**Link-Belt Construction Equipment Company**

Re: **EQ 14-004, 13E-061**

# Technical Bulletin

SUBJECT: CARRIER CAB SEAT BELTS

Figure 1  
Seat Belt Buckle Inspection Guide

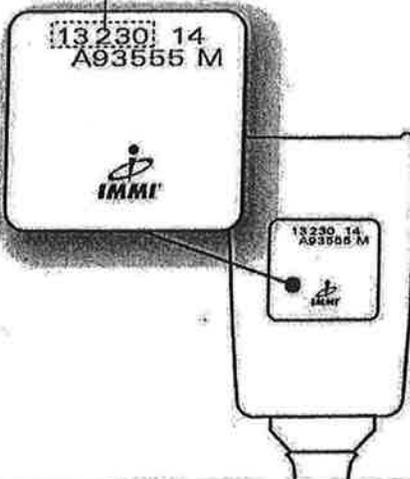
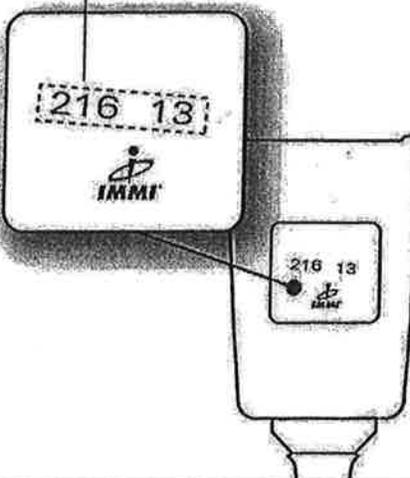
The purpose of this bulletin is to inform of the requirement to inspect the date codes on the seat belts in the carrier cab.

Link-Belt received notification from the supplier of the seat belt assembly used in the above listed cranes of a potential issue in the release mechanism in the buckle end of the assembly. If you have taken delivery of one of the above Link-Belt model cranes on or after August 1, 2013, inspect the date code on the back housing of the buckle. Refer to Figure 1. There are two different date code formats. If the buckle date code is within either of the ranges shown, immediately contact your Link-Belt Distributor for a free replacement. The affected seat belt assembly must be surrendered to your distributor to obtain the free replacement.

Suspect code range is  
**13220 through 13256**

Suspect code range is  
**214 13 through 256 13**

Link-Belt Distributor: As a distributor, a standard warranty claim must be filed to Link-Belt for reimbursement of the new assembly. You must reference the date code of the assembly with a photograph when filing the claim for reimbursement.
